<b>Subject:</b> HESITATION / IDLE VIBRATION DUE TO CRACKED ENGINE MOUNT	<b>Bulletin No:</b> 01-001/09
	<b>Last Issued:</b> 1/20/2009

- This bulletin supersedes the previous bulletin 01-021/06, issued 6/13/2006. The DESCRIPTION, REPAIR PROCEDURE, PART(S) INFORMATION and WARRANTY INFORMATION sections have been revised.
- Changes are noted below beside the change bar in Red.

2004-2005 RX-8 vehicles with VINs lower than JM1FE\*\*\*\*\*154999 (produced before May 6, 2005)

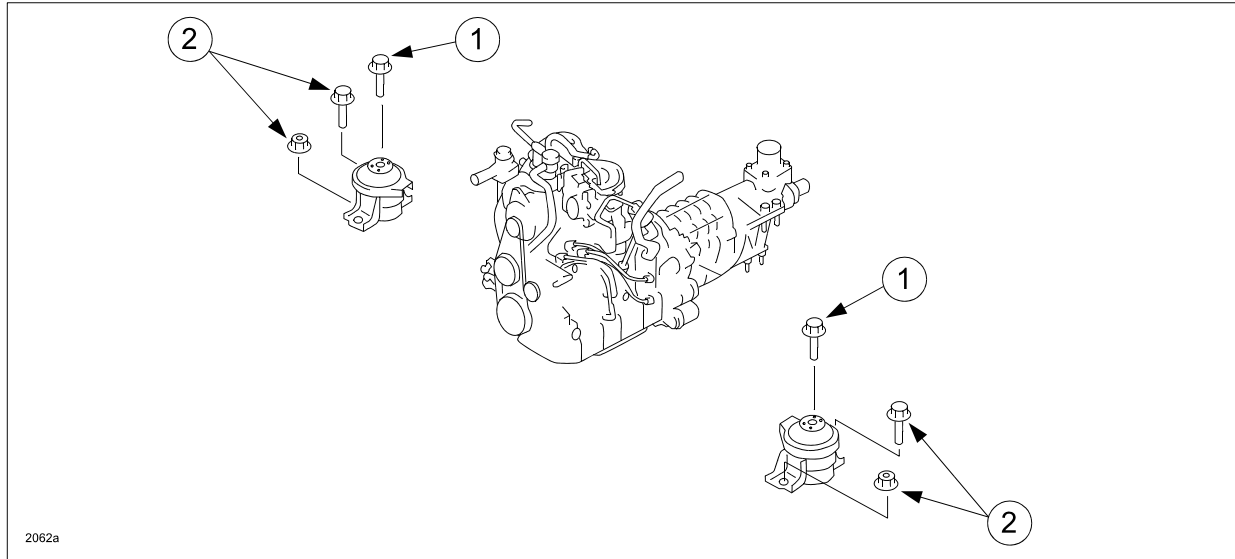
Depending on the driving condition or engine condition, the RH side engine mount rubber may deform. As a result, the RH side engine mount can crack. As a mass production change, the material of the engine mount rubber has been changed.

- RH engine bracket replacement is no longer necessary.
1. Verify customer concern.
  2. Place vehicle on hoist.
  3. Remove engine cover. Refer to MS3 online service information or Workshop Manual section 01-10 ENGINE COVER REMOVAL/INSTALLATION procedure.
  4. Raise and support vehicle on hoist.
  5. Remove front wheels.  
**Tightening Torque: 147 N.m (108 ft-lb)**
  6. Support engine using an engine hoist.

- a. Engine mount bracket-to-engine mount (1).  
**Tightening Torque: 37-52 N.m (28-38 ft-lb)**
- b. Engine mount-to-front sub frame (2).  
**Tightening Torque: 45-63 N.m (33-46 ft-lb)**

- a. Engine mount bracket-to-engine mount (1).  
**Tightening Torque: 37-52 N.m (28-38 ft-lb)**
- b. Engine mount-to-front sub frame (2).  
**Tightening Torque: 45-63 N.m (33-46 ft-lb)**
